**Project:** Police Memorial and North Cove  
Marina Electrical Vault Resilience  
Project Construction Services  
(November 2015)

**RE:** Addendum # 2  
**# of Pages:** ( 7 pages)

The following revisions and/or clarifications are to be made to the Request for Proposals for “**Police Memorial and North Cove Marina Electrical Vault Resilience Project Construction Services**” in response to questions submitted by prospective proposers.

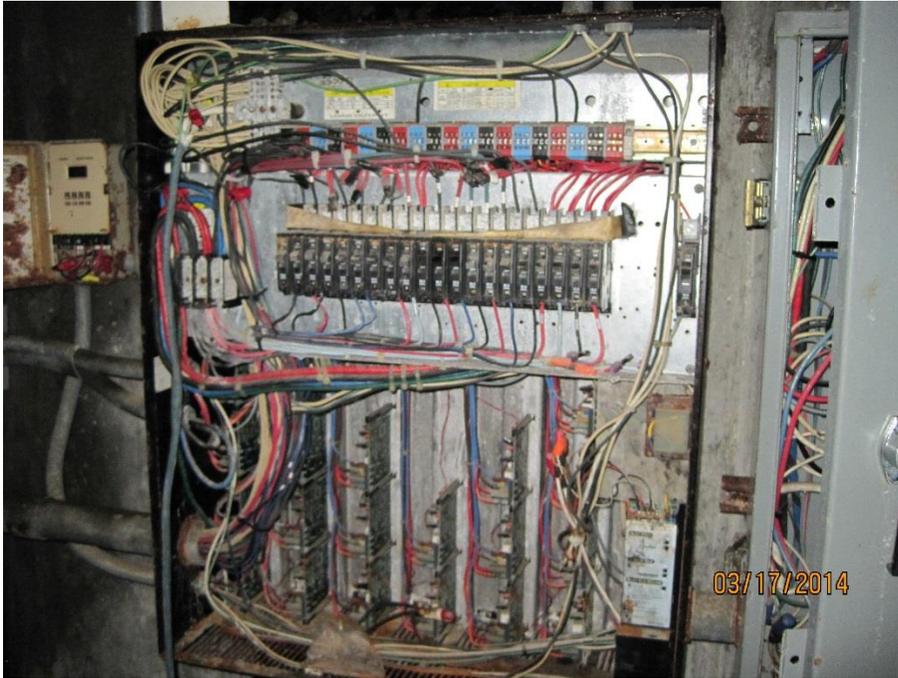
7. With reference to drawing E400 detail 1, please provide contact information for existing lighting Control system Manufacturer.

*The existing lighting control system is a Lutron system which was completely destroyed by Superstorm Sandy. See photo below. Contact telephone number for Lutron is [800-523-9466](tel:800-523-9466).*
